Further to our email of May 14th we now wish to highlight & "consolidate" the many issues regarding the unacceptable problems arising from the latest CEPC's tree replanting proposals, in order that a further, in depth, review can be undertaken by Camden.

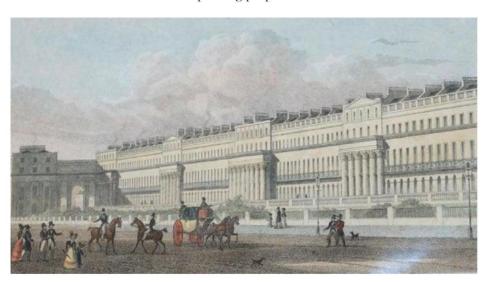
- 9. Below is the misleading picture that the CEPC is using to support their fundamentally flawed case for their tree replanting proposals.

10. It can be readily appreciated, from viewing the above image, that the objective of Longdstaff Gowan is fictional because there is no horse riding & no horse drawn carriages existing in Regents Park in 2024. Additionally, at the outset, it should be stated that there were no cars, no coaches, no lorries nor motor bikes in the 1820s; second, Regent's Park, itself, has fundamentally altered & dramatically changed during the last 200 years; third, the conditions in London in 2024 are fundamentally different + the socio-economic circumstances existing today, the way of life of its residents & their composition, differs significantly from 200 years ago... Also the following issues are now
